| Re: Recall Campaign Launch Notification Model 907 (Sprinter) Model Year 2020 Check Torque on Front Door Hinge Screws | DATE: June, 2021 |

| Campaign No. : | Campaign Desc. : | Check Torque on Front Door Hinge Screws |
| 2021060008 | VS3TURSCHA | |

SUBJECT: **Model 907 Sprinter, Model Year 2020**
Check Torque on Front Door Hinge Screws

D72.10-A007-79

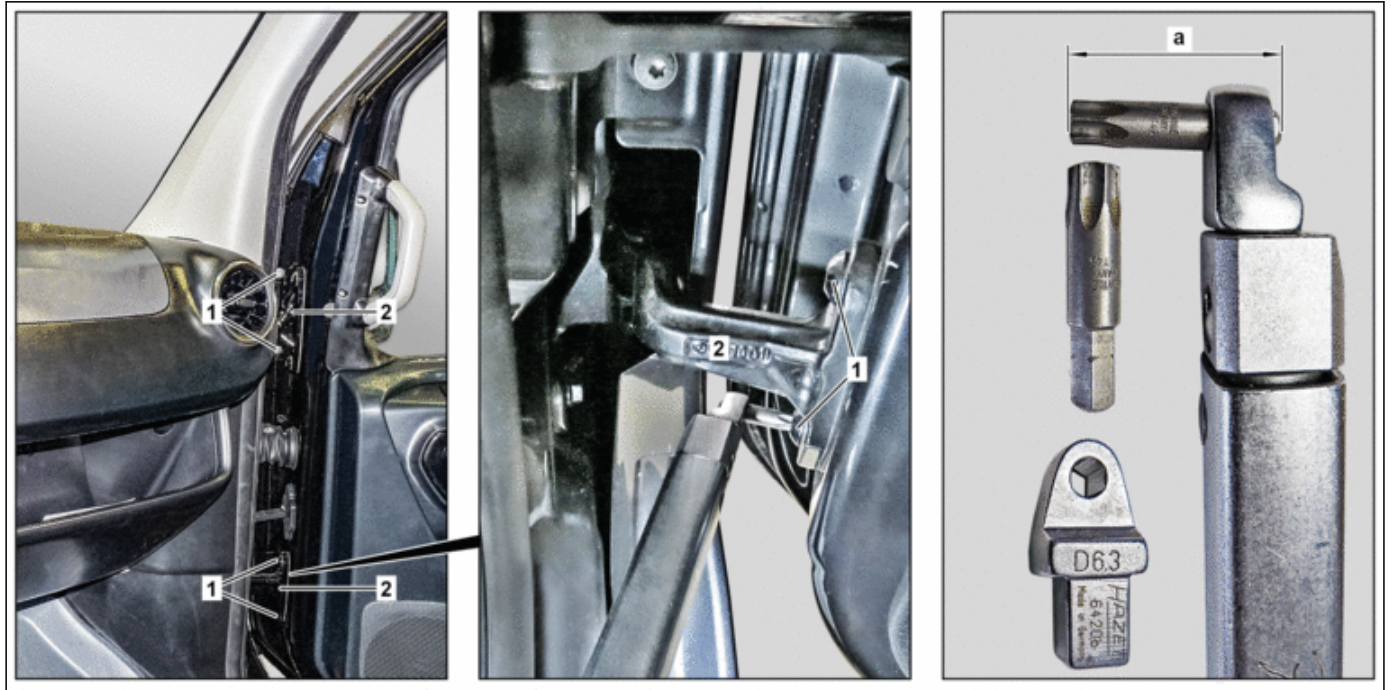
Check threaded connections of hinges (2) on **both** front doors.

| 3 | Check front door for play on screws (1) and hinges (2).  AR |  To do so, move front door e.g. abruptly. If front door exhibits play on the screws (1) or hinges (2), ↓ Adjust front door. If front door does not exhibit any play on the screws (1) or hinges (2), ↓ continue with operation step 4. | AR72.10-D-0550TS |
| 4 | Tighten screws (1). Note on calculation of tightening torque when using insertion or socket tools with various effective lengths | If the respective front door does not exhibit any play on the screws (1) or hinges (2).  Use torque wrench attached at low eye-level height. Observe dimension (A).  Screw/bolt, hinge to front door | AH00.00-P-0015-01CW BA72.10-N-1010-01TS |

| Number | Designation | Model 907 |
|---------------------|---------------------------------|-----------|
| BA72.10-N-1010-01TS | Screw/bolt, hinge to front door | Nm 23 |
